Your Ref
Y/93/18/HH
Our Ref
PLAN-026036
Date
09/01/2019

Proposal: Single storey rear extension.
Site: 35 Fairholme Drive, Yapton, BN18 0JH.
Y/93/18/HH

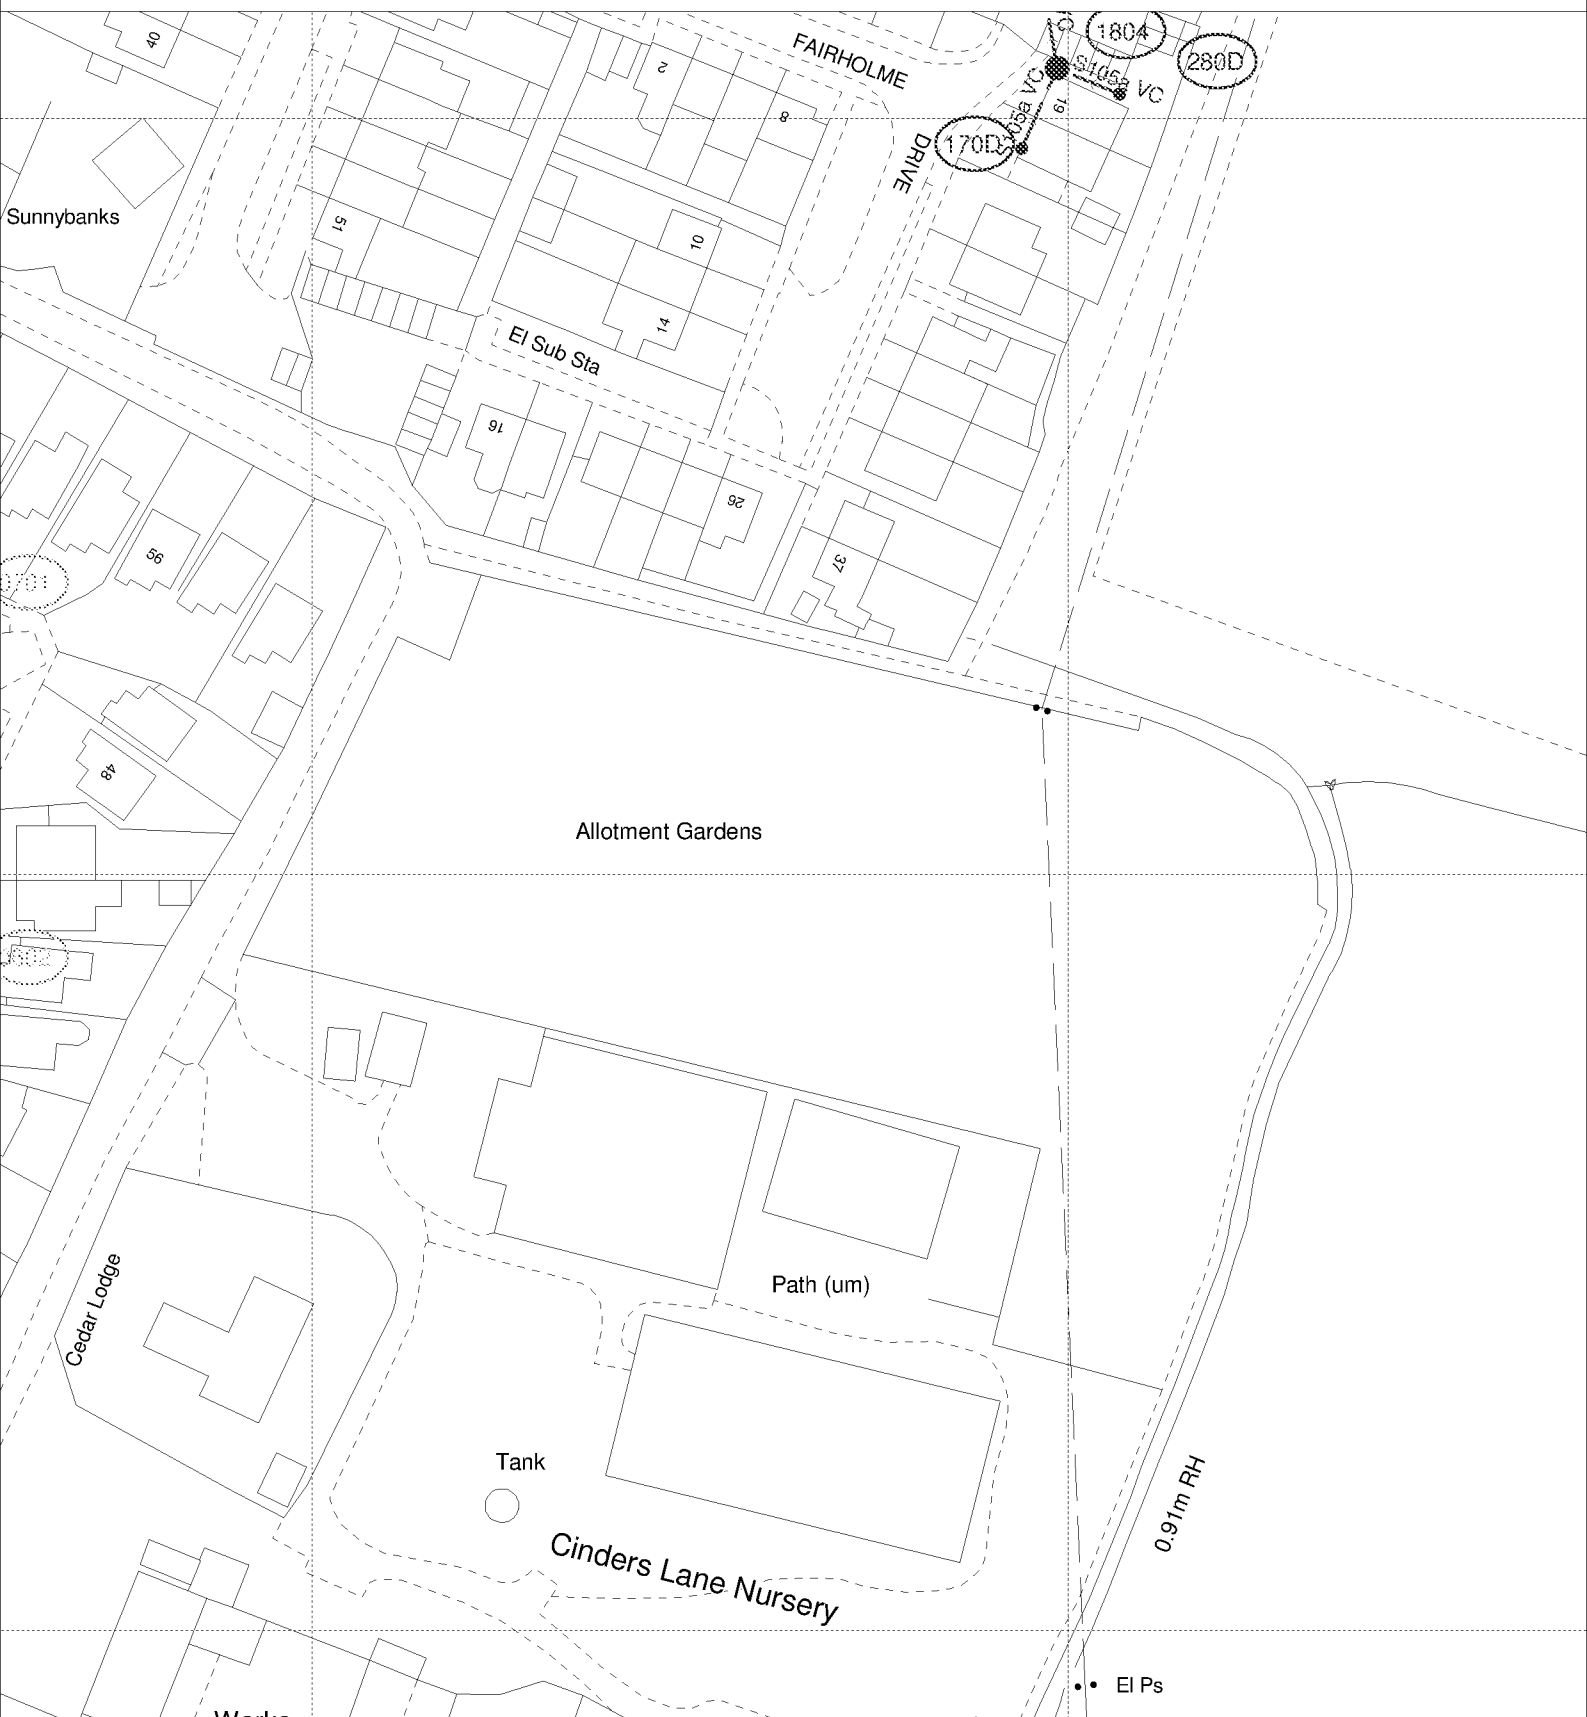
Due to surface water inundation issues in the Lidsey Catchment “The applicant is advised to adopt, where appropriate, the measures in the table “Practical measures to reduce the potential impacts of development”.

Developer should look to protect the public sewerage system from inundation and infiltration, which contribute to flooding in unfavourable conditions.
